## Nuclear Information and Resource Service

**RE: Safety Evaluation of the Core Shroud Fix at Oyster Creek Nuclear Generating Station**

SHROUD RESTRAINT ASSEMBLY  
LOWER HOOK  
FIGURE 4

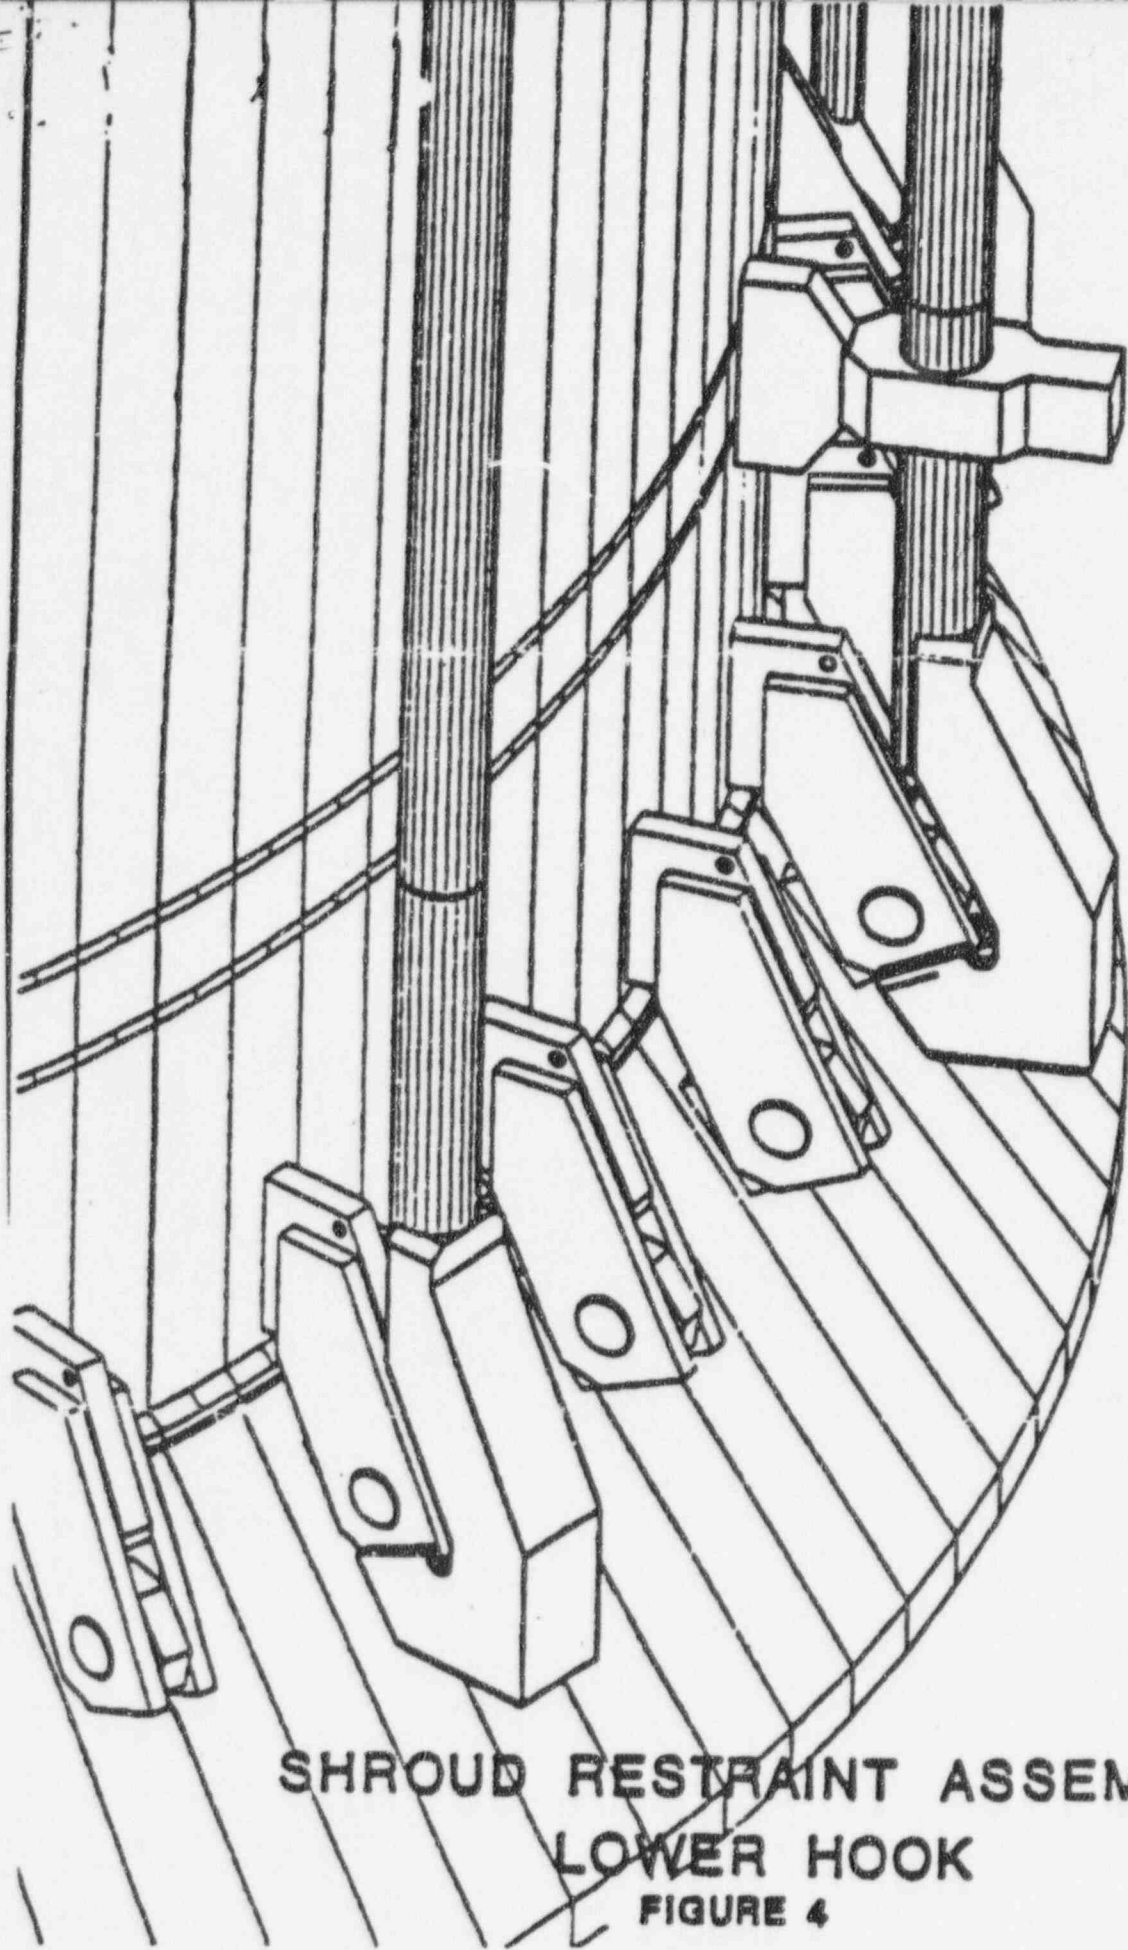
Specifically, NIRS concerns with the Oyster Creek's Core Shroud Repair focus on the Shroud Restraint Assembly Lower Hook depicted in Figure 4 of the NRC Safety Evaluation dated November 25, 1994. [Attached]

NIRS contends that the lower hooks for the restraint assemblies are dependent on the originally installed gussets, which in turn are composed of plates of Type 304 stainless steel and Inconel 600. NIRS contends that the anchor system utilized for the core shroud fix is dependent upon a susceptible material which has been subject to long-term exposure by the same harsh operational environment that incubated cracking of the core shroud. These conditions are identified in NUREG/CR-5754 "Boiling Water Reactor Internals Aging Degradation Study."

NIRS contends that both the NRC and the licensee ignored information contained within NUREG/CR-5754 which warns that it is "essential to control or eliminate stressors" (emphasis added). To the contrary, GPUN incorporated "a susceptible material" in the fabrication of the anchor system for the core shroud fix, namely, Type 304 stainless steel and Inconel 600 which have been subjected to aging conditions for 25 years during the reactor's operation.

- 1) Has the NRC staff evaluated or reviewed the licensee's evaluation of the effects of stress corrosion cracking (SCC), fatigue, erosion, embrittlement, and creep on the plate material and its Heat Affected Zones (HAZ) which fabricates the gussets? Is that documentation available for public review?

- 2) Given that a susceptible material has already been incorporated into the Shroud Restraint Assemblies, what has the licensee done to mitigate the other two conditions necessary to incubate SCC as described in NUREG/CR-5754?

- 3) Where has NRC or the licensee evaluated the consequences of the failure of one or more Type 304 stainless steel gussets used to anchor the Shroud Restraint Assemblies?

- 4) Does the NRC plan to require frequent enhanced inspections of the tie rod anchor plates in question? If so, what does the NRC consider to constitute frequent and enhanced inspections for aging related deterioration? If not, why not?
